**CITY PLAN COMMISSION****THURSDAY, JANUARY 23, 2025****FILE NUMBER:** S245-048**SENIOR PLANNER:** Hema Sharma**LOCATION:** Travis Street, north of Oliver Street**DATE FILED:** December 26, 2024**ZONING:** PD 193 (MF-2)**PD LINK:** <https://dallascityhall.com/departments/city-attorney/Articles/PDF/Article%20193.pdf>**CITY COUNCIL DISTRICT:** 14**SIZE OF REQUEST:** 1.2413-acres**APPLICANT/OWNER:** Tyler Sibley, Kairoi Properties, LLC; Brian O'Boyle Sr., Berryset II Uptown LTN, LLC

**REQUEST:** An application to replat a 1.2413-acre tract of land containing all of Lots 12 through 16 in City Block1/1531 to create a 17-lot shared access development with lots ranging in size from 0.0471-acre (2,051 square feet) to 0.0957-acre (4,167 square feet) on property located on Travis Street, north of Oliver Street.

**PRELIMINARY PLAT**  
**KNOX RESIDENCES ON TRAVIS**  
**SHARED ACCESS DEVELOPMENT**  
**LOTS 1-17 BLOCK 11531**  
 BEING A PART OF THE 6.6 AC. (11531)  
 COCKRELL FARMLAND ADDITION  
 CITY OF DALLAS, DALLAS COUNTY, TEXAS  
 CITY FILE NO. S245-048  
 ENGINEERING PLAN NO. 3117-

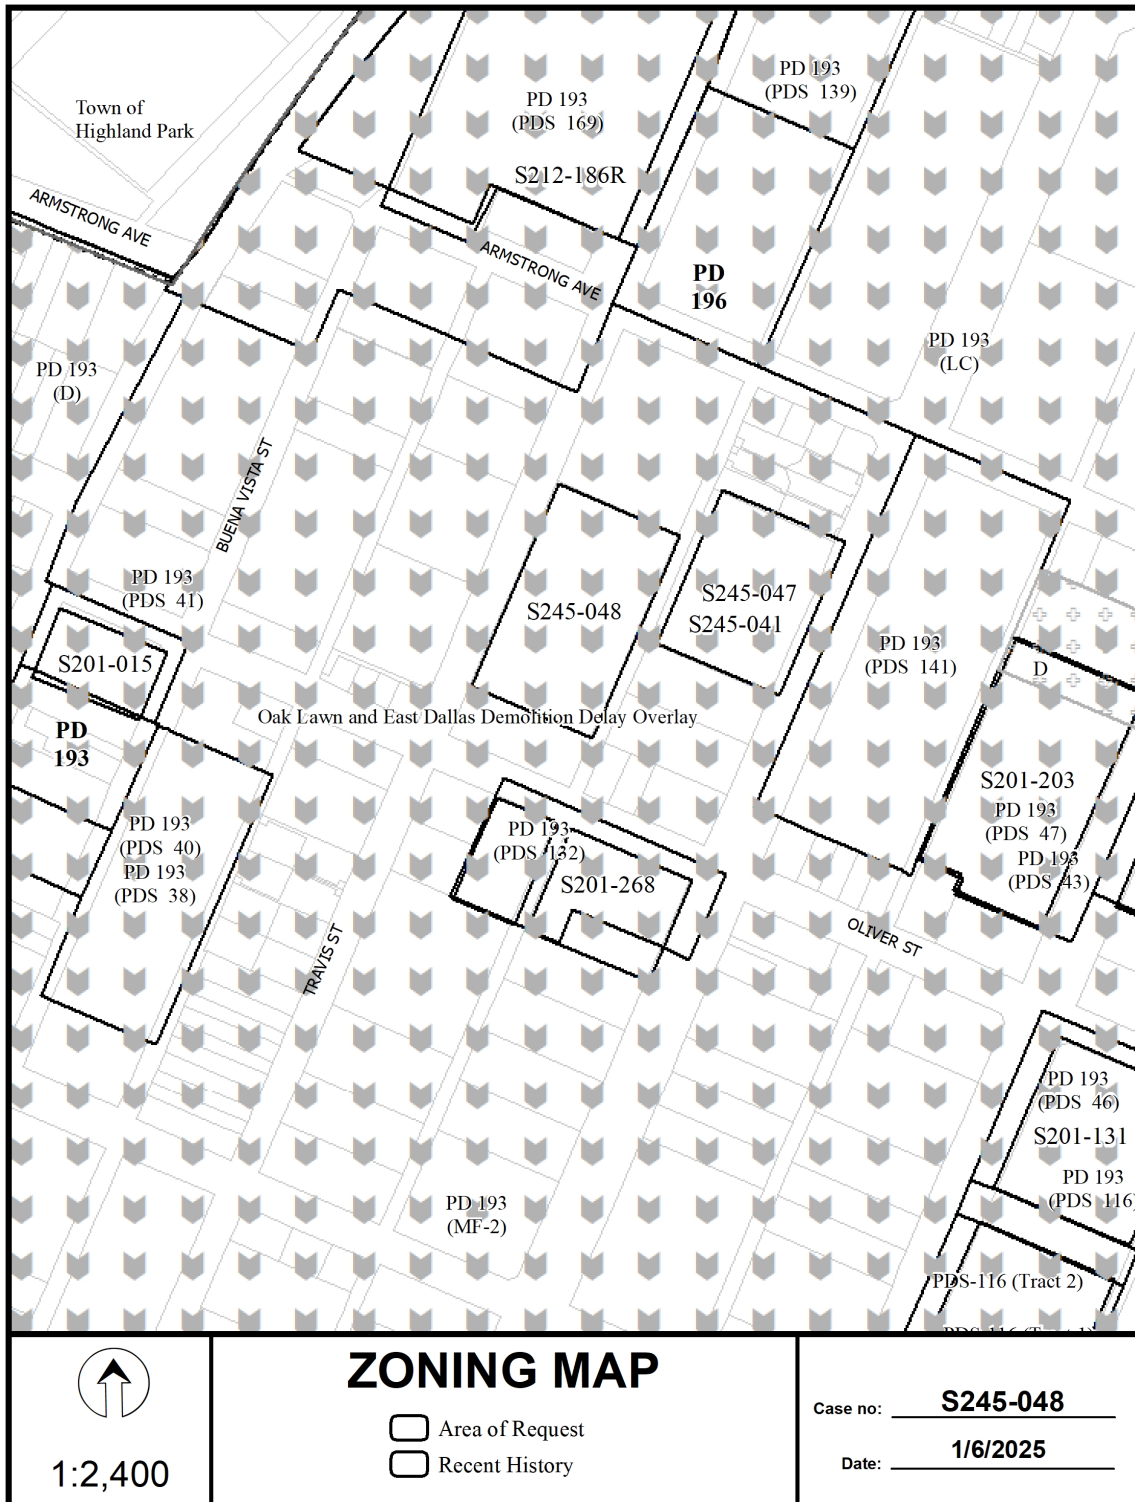
**STAFF RECOMMENDATION:** The request complies with the requirements of the PD 193 (MF-2); therefore, staff recommends approval of the request subject to compliance with the following conditions:

7. On the final plat, include two boundary corners tagged with these coordinates: "Texas State Plane Coordinate System, North Central Zone, North American Datum of 1983 on Grid Coordinate values, No Scale and no Projection."

11. The number of lots permitted by this plat is 17.

21. Provide additional shared access area easement, up to 26 feet, for compliance to Dallas Fire Code when building height is 30 feet or greater.
22. A water and wastewater easement at least 12 feet wide to be used exclusively for public water and wastewater below grade must be provided within the Shared Access Area Easement & labeled on the plat. Section 51A-4.411(d)(2) and Sections 49-60(d), 49-61(c)(5)(B), and Development Design Procedure and Policy Manual Section 6.2

26. A shared access development is treated as one lot for the purpose of setbacks and lot coverage.
27. Regardless of the minimum front yard setback of the applicable zoning district, the minimum front yard setback must be at least 20 feet from the right-of-way line of a street or alley if the parking space for the lot(s) is located in an enclosed

structure and if the space faces upon or can be entered directly from the street or alley. Section 51A-4.411(f)(2)

28. Include the words "Shared Access Development" in the title block of the final plat. Platting Guidelines
29. Place a note on the final plat stating: "No vehicular access is permitted to adjacent property outside the platted property from the shared access area except to a public or City Council approved Private Street." Section 51A-4.411(d)(3), and 51A-4.411(d)(10)
30. If a guard house is provided, it must be at least 30 feet from the shared access point. Section 51A-4.411(d)(8)
31. The Shared Access Area Easement must be terminated a minimum of 3 feet from the adjacent property or right-of-way. Section 51A-8.618(b)
32. Provide guest parking at a rate of 0.25 spaces per dwelling unit and with adequate maneuverability per the Shared Access Development requirements.

37. On the final plat, change "Travis Street" to "Travis Street (AKA Travis Avenue FKA Preston Avenue)". Section 51A-8.403(a)(1)(A)(xii).
38. On the final plat, identify the property as Lots 1-17 in City Block B/1531.
